Re: Office of Engineering and Technology Seeks to Supplement the Incentive Auction Proceeding Record Regarding Potential Interference Between Broadcast Television and Wireless Service, ET Docket No. 14-14; In the Matter of Expanding the Economic and Innovation Opportunities of Spectrum Through Incentive Auctions, GN Docket No. 12-268

**COMMENTS OF THE  
NATIONAL ASSOCIATION OF BROADCASTERS, ABC TELEVISION AFFILIATES  
ASSOCIATION, FBC TELEVISION AFFILIATES ASSOCIATION, CBS TELEVISION  
NETWORK AFFILIATES ASSOCIATION, NBC TELEVISION AFFILIATES, THE  
ASSOCIATION OF PUBLIC TELEVISION STATIONS, THE CORPORATION FOR  
PUBLIC BROADCASTING, AND THE PUBLIC BROADCASTING SERVICE**

March 18, 2014

Figure 1.

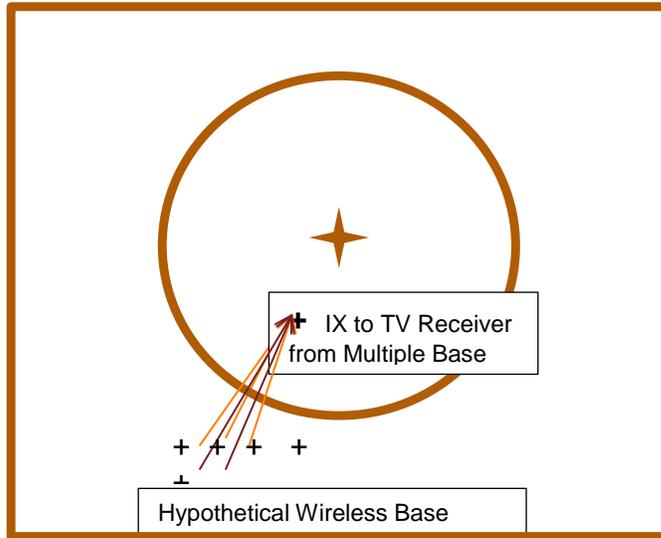
To predict potential interference from wireless service to broadcast DTV, the OET methodology assumes a deployment of hypothetical wireless base stations uniformly spaced every ten kilometers, with transmitting antennas at 30 meters above ground, in every wireless license area within 500 km of the DTV facility. Undesired field strength from each hypothetical base station is then predicted at each grid point within the DTV coverage area, and the desired to undesired signal (“D/U”) ratio is determined by comparing the predicted or desired DTV signal and the interfering or undesired signal from a *single* individual hypothetical base station to determine whether that hypothetical base station is predicted to cause interference.

In reality, wireless providers are likely to have a large number of cell sites in close proximity operating over a wide area with high traffic volumes at multiple base stations at the same time. Transmissions from multiple base stations can combine and cause interference to DTV service, even in cases where a single wireless signal may not cause interference.

This signal combining interference phenomena is well understood. In fact, the recently established rules governing Digital Television Distributed Transmission Systems (“DTS”) address this issue.<sup>39</sup> DTS employ multiple synchronized transmitters spread around a DTV station’s service area similar to a wireless cellular network architecture. To ensure that DTS transmissions do not interfere with DTV reception, the rules provide that the *combined* effect of all DTS transmitters must be taken into account in interference calculations. Specifically, the Commission requires that the root-sum-square (RSS) method of calculating interference from multiple DTS transmitters must be used to calculate both adjacent channel and co-channel interference.<sup>40</sup>

proposed OET methodology, a DTV receiver receiving a 65 dB $\mu$  DTV signal and two 50 dB $\mu$  interfering signals from two proximate co-channel wireless sites would be deemed to have no interference since each wireless base station would meet the 15 dB D/U ratio (for each transmitter,  $D/U = 65 \text{ dB}\mu - 50 \text{ dB}\mu = +15 \text{ dB}$ ). However, these interfering signals will have an additive effect and create interference when combined. Using the RSS method, the two 50 dB $\mu$  signals would result in 3 dB of additional interference at the DTV receiver or a D/U ratio of +12 dB rather than +15 dB. A D/U ratio of 12 dB would result in loss of service at that location.

As the Commission already found with multiple DTS transmitters, the combined interference effect of multiple transmitters needs to be taken into account and “the RSS method in virtually all situations will best approximate actual interference” from multiple transmitters to DTV signals.<sup>41</sup> Failure to consider the combined interference effect of multiple wireless base stations will result in increased interference to DTV stations. The Commission has a statutory responsibility to protect broadcasting and DTV viewers and cannot ignore “real world” interference from multiple wireless operations; thus, any methodology used to predict potential inter-service interference should take this into account. The Joint Broadcasters urge the Commission to consider interference from multiple wireless base stations using either a simple direct summation method or the RSS method utilized for calculating interference from multiple DTS transmitters under the current rules.

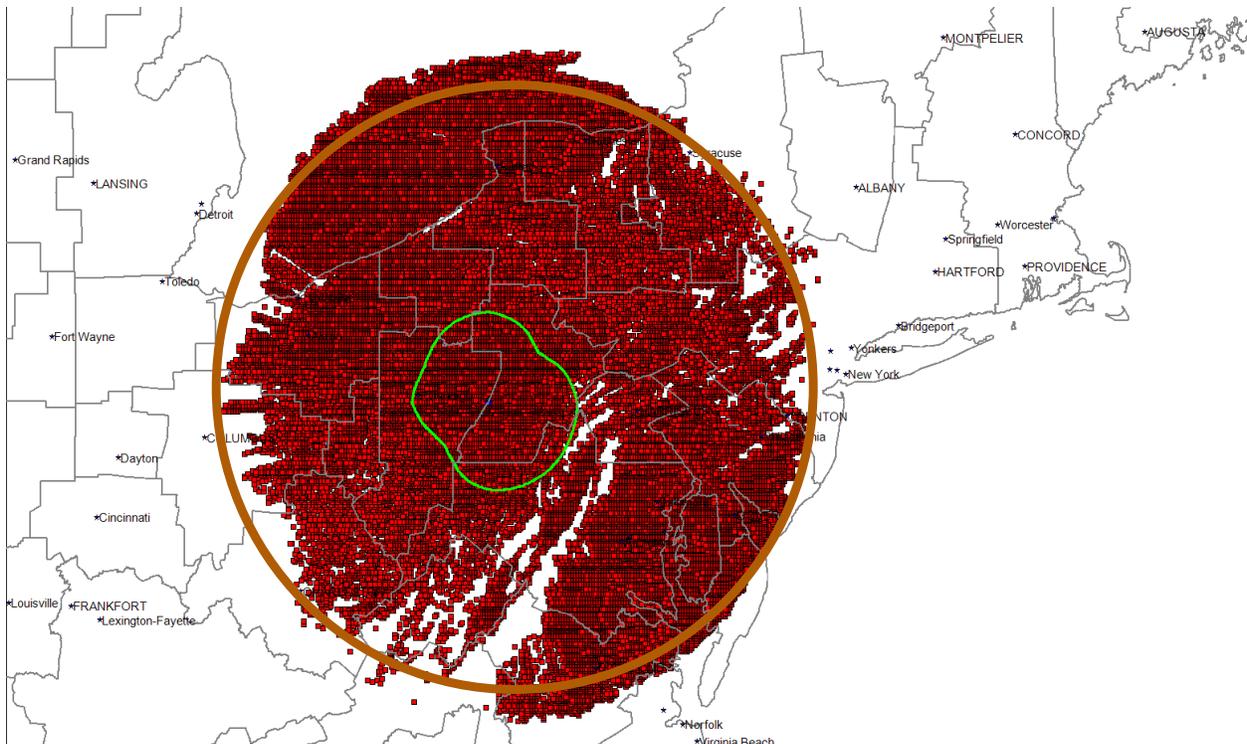
OET suggests that prescribing pre-defined separation distances, as proposed by commenters addressing the issue of co- or adjacent-channel interference, may be spectrally inefficient and overly conservative, and would effectively lump together all interference cases and apply separation distances based on a worst case scenario.<sup>68</sup> In fact, in its submissions on this issue, NAB did not “lump together” the interference scenarios, nor did it provide a “worst case” analysis. Rather, NAB provided a range of separation values and specifically noted that these distances are affected by the technical characteristics of the stations involved, such as transmitting height and power of DTV stations and wireless base stations.

NAB presented these distance calculations to demonstrate that a serious co- and adjacent-channel inter-service interference problem existed and that the Commission needed to take this issue into account in the auction process and beyond if it was considering a variable band plan. While OET should be commended for addressing this issue, its proposed methodology is unnecessarily complex in the context of an already challenging auction. Attempting myriad computations on “hypothetical” wireless deployments does not yield more accurate results nor provide more spectrum efficiency. A simpler approach, where separation distances are representative of potential interference between DTV and wireless service, is far easier to implement and will not sacrifice meaningful spectral efficiency.
